Technical Service Bulletin

Transaction No.: **2082617/1**

39 Noises in overrun (e.g. whining, howling) - vehicles with OBC

View of subframe from front

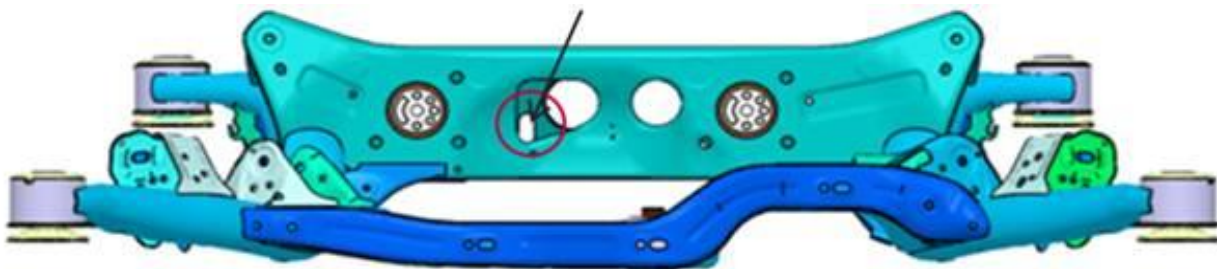
2) Knead it into a ball with a diameter of about 5 cm.

3) Attach the ball between rear final drive and rear axle subframe.

View of subframe from rear

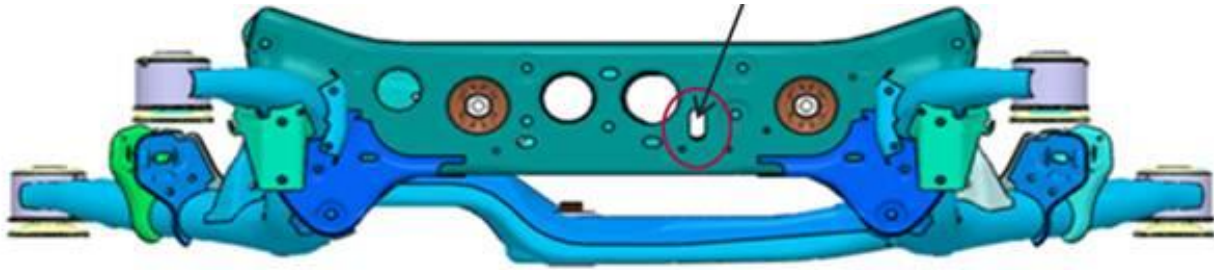
4) Press about 2/3 of the ball between the two metal cups of the subframe, so that some of the ball passes out through the elongated hole of the rear metal cup, as shown in the following illustration.
